Endpoint Solutions

Subject: Work Plan for Additional Investigative Services
Klinke Cleaners Fox Run at 2346 W St. Paul Avenue, Waukesha
DNR BRRTS Activity #: 02-68-535535; FID #: 268188910

WDNR RESPONSE

PROPOSED SCOPE OF WORK

FIGURE 3 FROM SAGA 11/14/11 STATUS REPORT

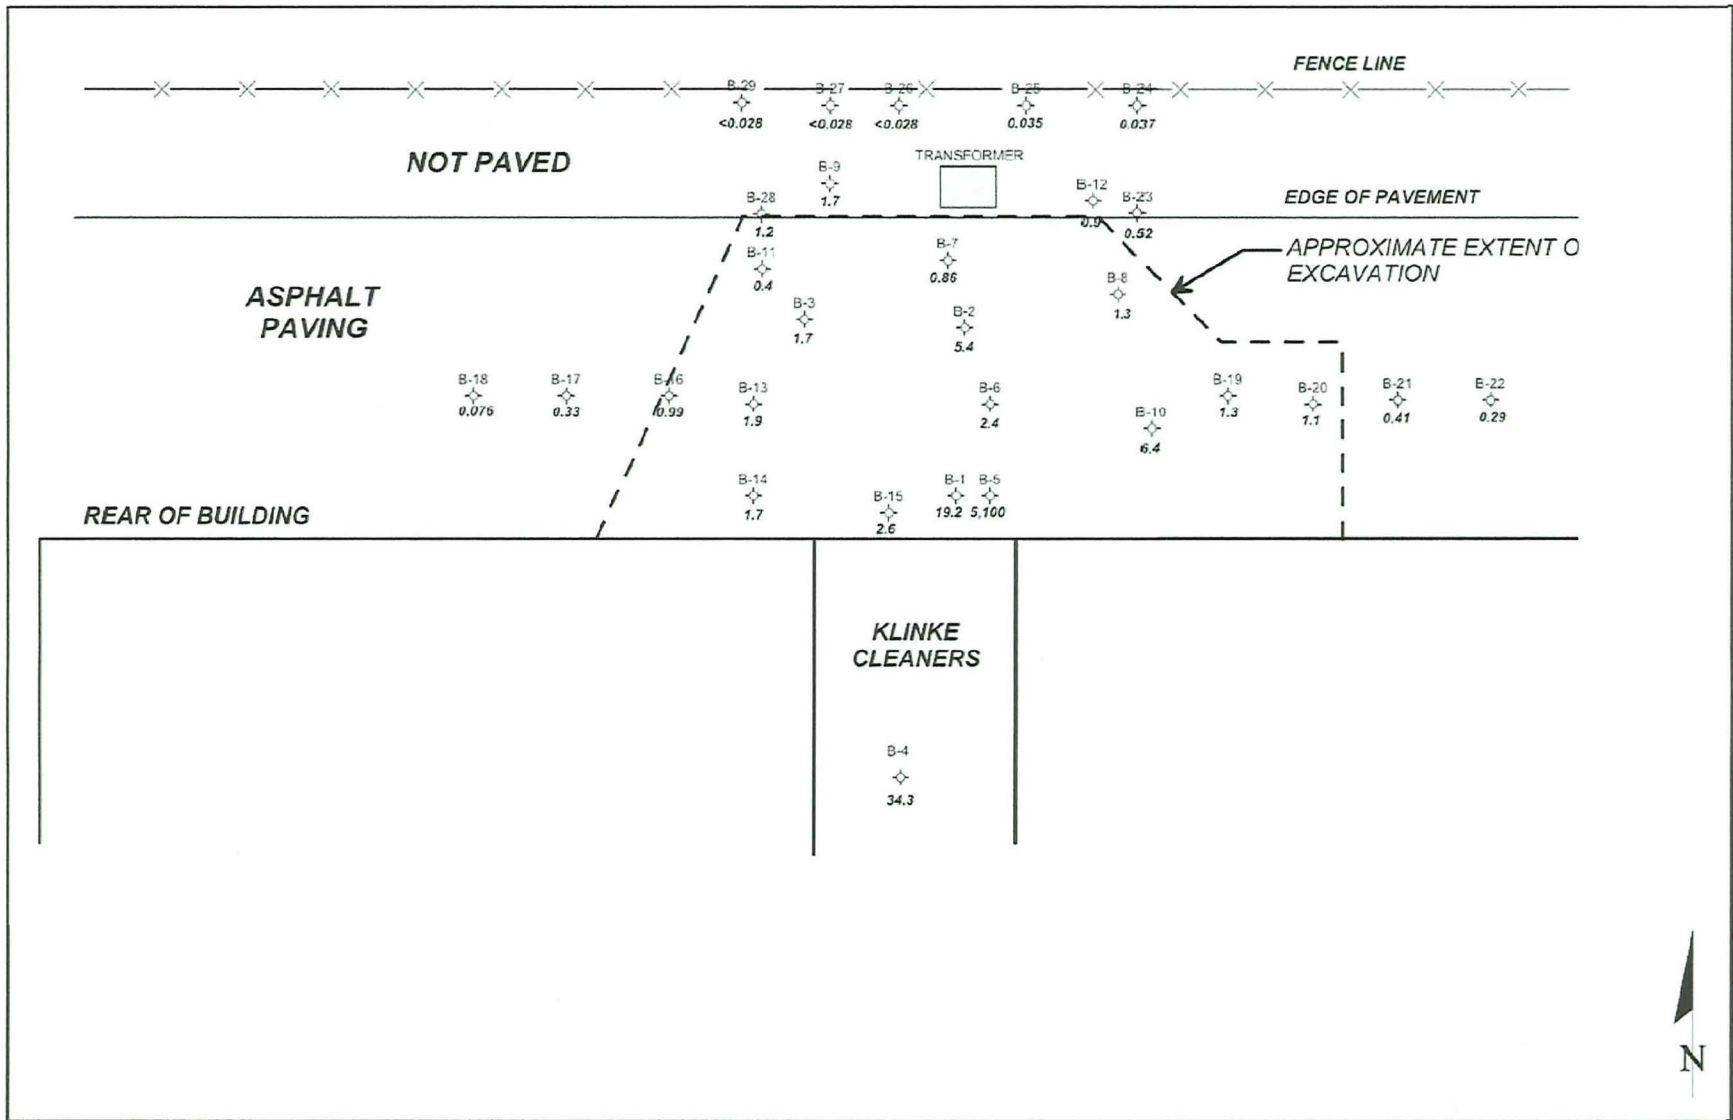
An error was discovered on **Figure B.2.a** and **Figure B.2.b** associated with the locations of soil sample locations B-28 and B-29. As shown on Figure 3 from the Saga November 14, 2011 Status Report, soil sample B-29 is actually located to the north of soil sample B-28; therefore, the extent of contamination to the north of the B-28 location has been delineated. A copy of the original Figure 3 from the Saga November 14, 2011 Status Report is attached in **Appendix A** and these two (2) sample locations have been corrected on **Figure B.2.b**, attached. Based on this information, it is our opinion that no further investigation is required to the north of the B-28 location.
